30 December 1963

Subject: FILM CONDITION IN RECOVERED M-26 SRV

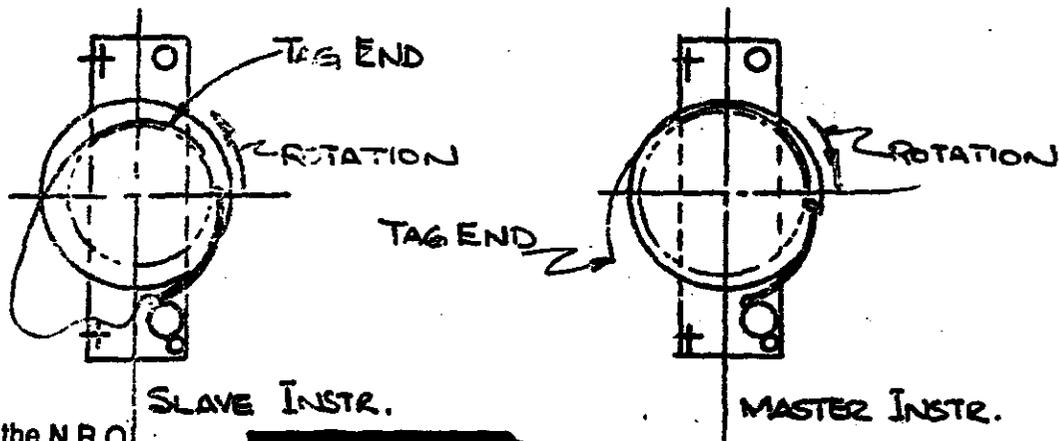
Initial cassette examination following aft cover removal established a piece of film, approximately 8 inches long, was jammed into the pot operating gear segment of the puck-arm assembly. This piece had to be removed to relieve the hung open puck-arm. This piece had one clean cut end, either from water seal or end of supply, and one badly frayed wrinkled end. The damaged end, by feel in the dark, matches the end of the piece on hand, which was discovered under the T/M tray during SRV handling in room lite.

The tag end of film on the master spool felt clean and square cut. The tag end of the slave spool was very tattered and damaged for an estimated 10 inches.

It is felt the tattering is caused by the following:

1. Extended operation of the cassette after cutter operation or supply run-out.
2. The mechanical configuration of the puck-arm to cassette rotation.

The indicated tag end length, due to mirror image puck-arm design, is not desirable. The offset position of the roller on the puck-arm is not desirable.

The S/I cassette-puck-arm assembly design must be reviewed. The unit should be redesigned to provide center of film roller contact to aid tracking, and provide identical puck-arm to direction of rotation configuration.
